ADDENDUM NO. 2

Company Supply & Admin Headquarters Bldg. Camp Clark Training Site Nevada, Missouri

PROJECT NO.: T2016-01

C-104.AD2 SCALE: 1" = 30'

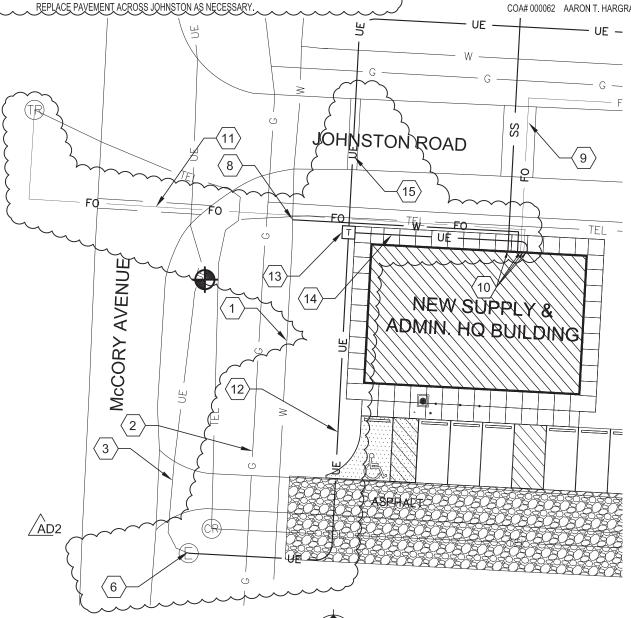
- 1. Sheet G-001
 - a. DELETE note in 1/G-001 SITE LOCATION stating "NOTE: FOR ADDITIONAL PROJECT LOCATION MAPS REFER TO INDIVIDUAL ROOF PLAN DRAWINGS".
- 2. Sheet G-002
 - a. DELETE work referenced in SCOPE OF WORK SCHEDULE under Sections 28 00 00.
- 3. Sheet C-102
 - a. ADD work as indicated on sheet C-102.AD2, (attached).
- 4. Sheet C-104
 - a. REVISE work for electrical utility as indicated on sheet C-104.AD2, (attached).

- 190 LF OF 2" CONDUIT FOR FIBER OPTICS LINE TO RUN TO EXISTING SERVICE PEDESTAL.
 SAWCUT AND REPLACE PAVEMENT ACROSS MCCORY AS NECESSARY. REFER TO DETAIL ON SHEET C-502

- CONTRACTOR TO INSTALL 143 LF OF 2" CONDUIT FOR SINGLE PHASE PRIMARY WIRE FROM EXISTING SWITCH CABINET. PRIMARY WIRE INSTALLED BY EVERGY.
- CONTRACTOR TO SET TRANSFORMER PAD. PAD PROVIDED BY EVERGY. TRANSFORMER PROVIDED & SET BY EVERGY.

- CONTRACTOR TO INSTALL 229± LF OF 3" CONDUIT FOR SINGLE PHASE SECONDARY WIRE. SECONDARY WIRE INSTALLED TO METER BY CONTRACTOR. REFER TO DETAIL ON SHEET C-502

- CONTRACTOR TO INSTALL 48 LF OF 2" CONDUIT FOR SINGLE PHASE PRIMARY WIRE FROM NEW ADMIN BUILDING TRANSFORMER TO NEW BARRACKS TRANSFORMER. PRIMARY WIRE INSTALLED BY EVERGY THE CONDUIT TO END JUST NORTH OF JOHNSTON ROAD, MARK END OF TRANSFORMER AT SURFACE FOR CONTINUATION BY BARRACKS CONTRACTOR. SAWCUT AND REPLACE PAVEMENT ACROSS JOHNSTON AS NECESSARY.
